York Minster

Care of Cathedrals Measure: Detailed Matters Application

Installation of a Statue of Queen Elizabeth II to the West Front of York Minster

APPLICATION FOR THE APPROVAL OF FINAL DETAILS.

02: detail of the sceptre proposed for casting

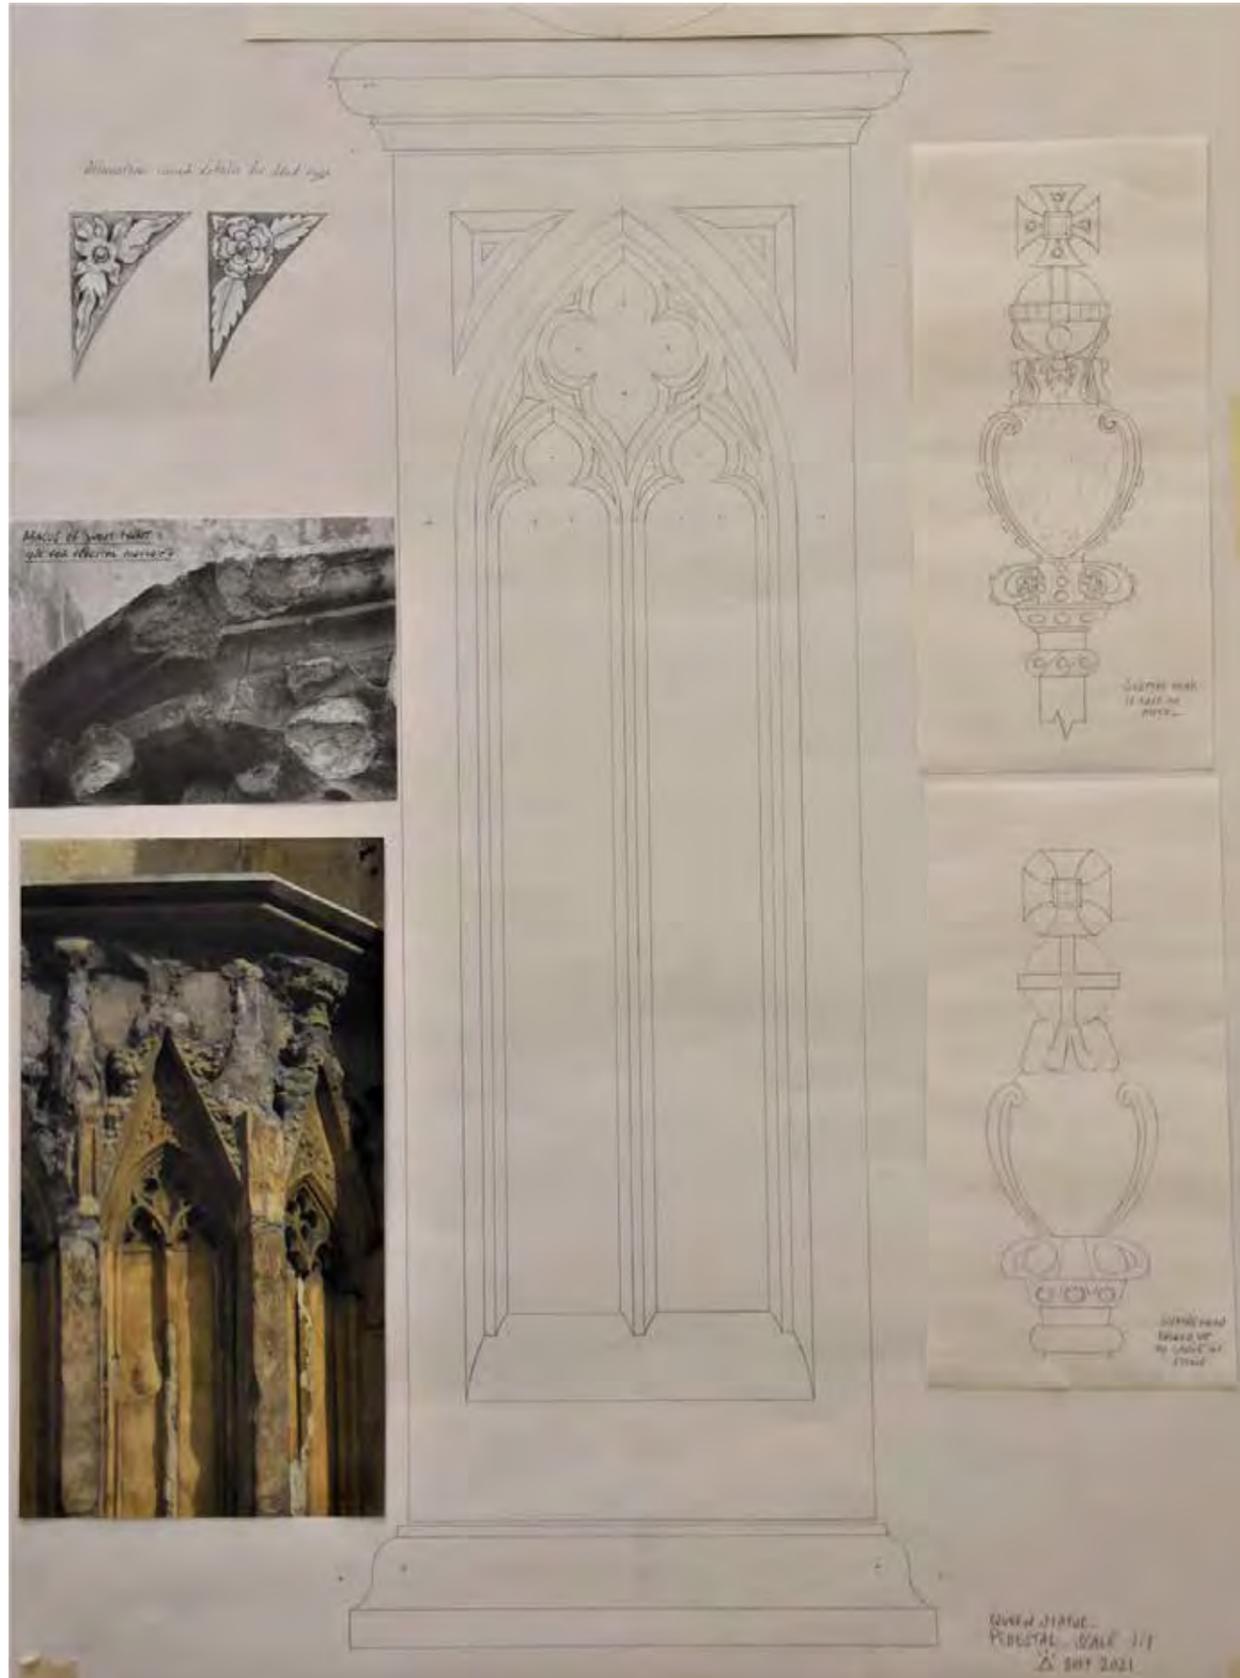
- **The casting question:** We agree with the CFCE that the diadem should be in stone. We are submitting in this application for the sceptre and orb to be cast. What we propose is for castings that would be patinated so as not to result in staining of the stone or for maintenance of finishes. We have now started work with a foundry who are confident that they can deliver this performance requirement. On the basis of their confident advice, we submit that it is essential that these two crucial elements of the sculpture, which are critical to the symbolism and understanding of the statue, must be in patinated cast metal.

As noted in the executive summary, we agree with the CFCE that the crowning diadem should be in stone. We are submitting in this application for the sceptre and orb to be cast in patinated metal.

What we propose is for castings that must be patinated metal so as not to result in staining of the stone or require any maintenance of a decorative finish.

We have now started work with a foundry who are confident that they can deliver this performance requirement. On the basis of their confident advice, we submit that it is essential that the orb and sceptre, which are crucial elements of the sculpture and also critical to the symbolism of the statue, must be in non-staining patinated cast metal.

Besides the justification which requires legibility of these elements, there are other practical considerations. Whereas the diadem will be given a good degree of shelter from weather erosion by the hooded niche, the orb and sceptre will be much more exposed. These elements will also be lower and more visible (as they have to be, to express the narrative of the statue as depicting the head of state and church). Also both these elements are seen much more three dimensionally than the diadem, so they cannot be thickened up and made more robust in stone.

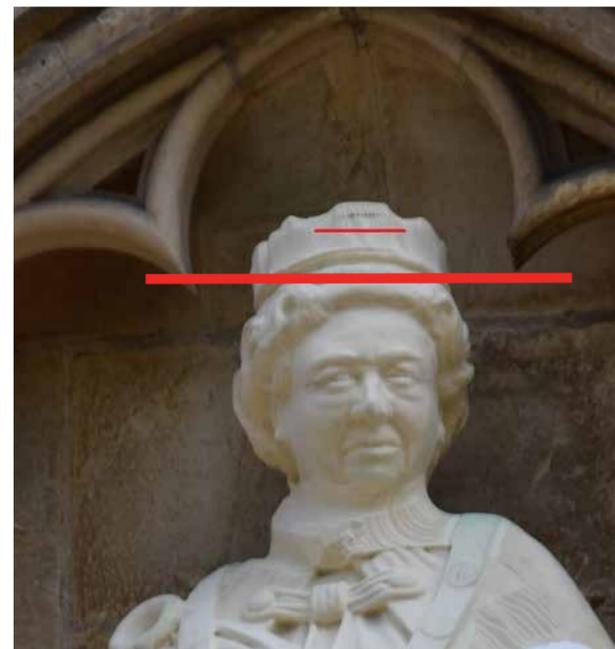
There are several effects that will reduce the scale of the statue from the mock up that was seen by the CFCE delegation:

- The statue will be lower overall by 1.5" due to the current slope of the niche base
- The head and overall height will be reduced once the head is correctly carved.
- Because the back of the niche is out of vertical, the head of the statue will also be set back into the niche further - so will seem less proud than the mock up.

The net result illustrated to the right is that the head of the statue will appear to be closer to the points of the cusps, giving more generous and comfortable space around the statue.

Comparison of the statue in the niche at 4 different scales with dimensions.

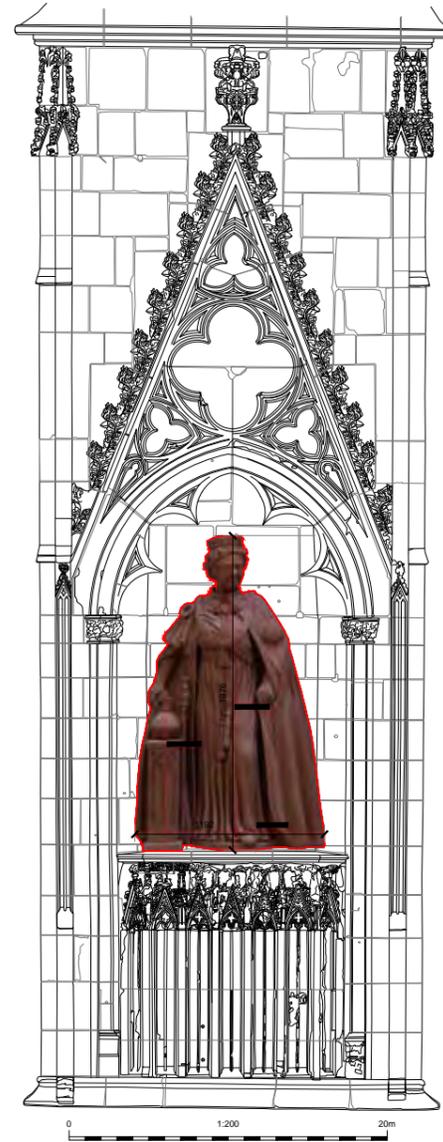
The Commission would find it helpful to see visualisations of the statue at 95%, 90% and 85% scale in the niche to see if that produces a better visual relationship with the cusps in the niche, against which it is currently fairly close. The Commission also noted that casting some elements of the statue in metal may have long-term maintenance implications and that for this reason, and in view of the fact that the statue will be some distance away from observers in any case, it would be better for the entire statue to be of stone, even at the cost of some loss of detail.

01. Statue as proposed 100%: note that the top of the head once set out correctly in the niche co-incides with the points of the cusps, which is quite different to the view seen on site by CFCE delegates.

02. Statue as proposed 95%

03. Statue as proposed 90%

04. Statue as proposed 85%

The reason that 95% does not work can be understood when considering the ground-level views in both the long view and the shorter more angled views.
